Subject: Requesting Class II permissive change for FCC ID: 2AXJ4KS220

The purpose of this letter is to request a Class II Permissive change for FCC ID: 2AXJ4KS220, original granted on 07/19/2022.

(The left photo is original, the right photo is new.)

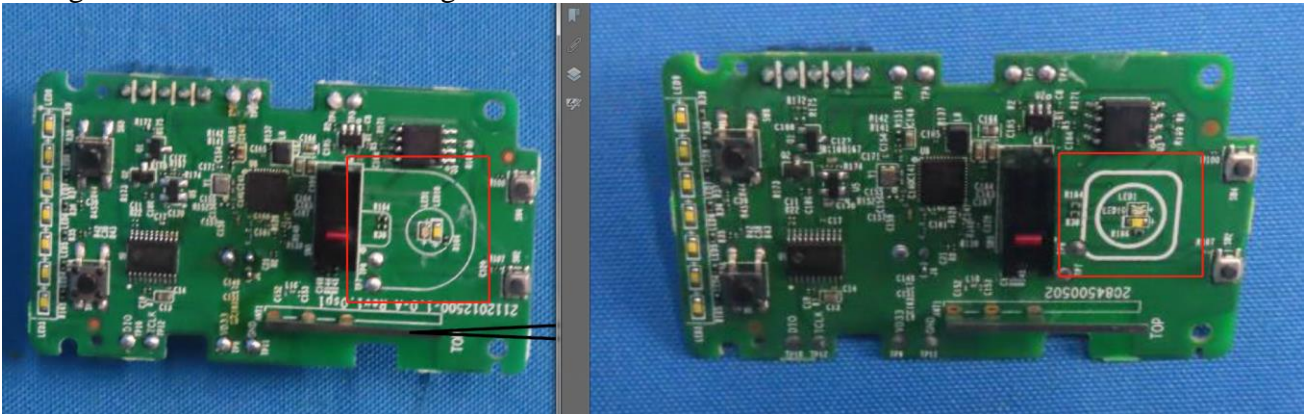
1. Changed the power board.
2. The device has been adjusted the position of the Wi-Fi board as below, others are kept the same.
 - (1) Update the screen printing of the shading foam to ensure accurate placement of the foam;
 - (2) The LED at the button rotates 90° and moves down to improve the uneven green light indication of the LED ring.
